**Haskoning Australia PTY Ltd.  
Maritime & Aviation**

**Subject: Arrawarra Creek Revetment – Assessment for NSW Coastal Panel**

## 3. Comments by RHDHV on technical proposal for rock revetment

### Back Lagoon, Merimbula

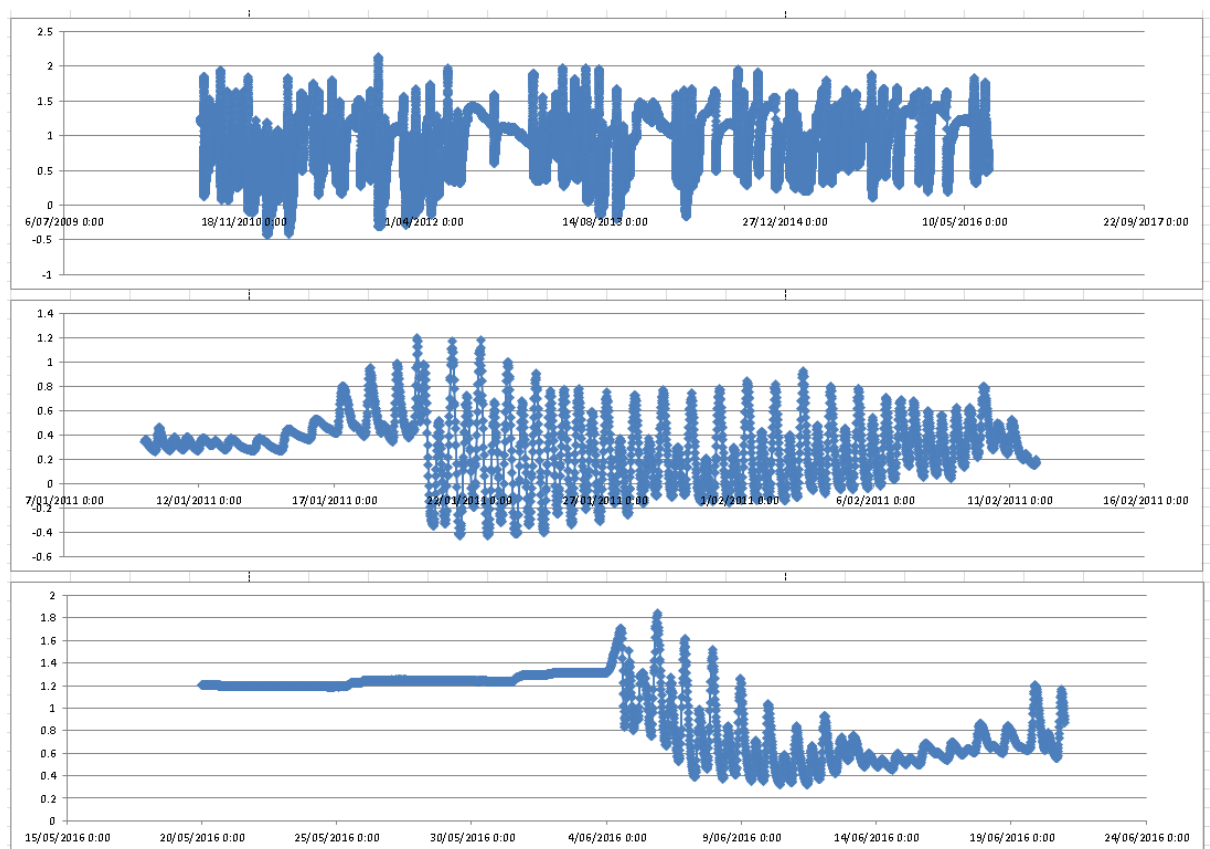
<p>through the recent June 2016 storm event.</p> <p>We can see that for these three systems of comparable size to Arrawarra Creek, this limiting saddle level was approximately -0.4 m AHD for Werri Lagoon, -0.1 m AHD for Back Lagoon and 0.45 m AHD for Saltwater Lagoon.</p> <p>Having regard therefore to the information before us, RHDHV would be suggesting that a saddle level of -0.4 m AHD should therefore represent <b>a maximum entrance saddle level</b> for the calculation of design storm wave penetration. This is 0.6 m below the +0.2 m AHD saddle level adopted by the proponent which could be expected to lead to significantly higher wave penetration.</p>	
17	Ref 8, 3.4.2, states that “wave climate at the revetment during severe storms is depth-limited”. This would seem to be reasonable.	Comment.
18	Ref 8, 3.4.2, lists in Table 6 design significant breaking wave heights at the estuary entrance for 1 and 6 hour duration 100 year ARI storms, for mean wave periods between 7 and 14 s, and for 100 and 50 year ARI storm tide levels (32 wave heights listed). The design wave heights range from 1.9 to 2.4 m, with average 2.2 m. While this approach would seem to be reasonable, the wave heights are likely to be low given the reduction in the entrance saddle bed level (see Item 16).	Comment.
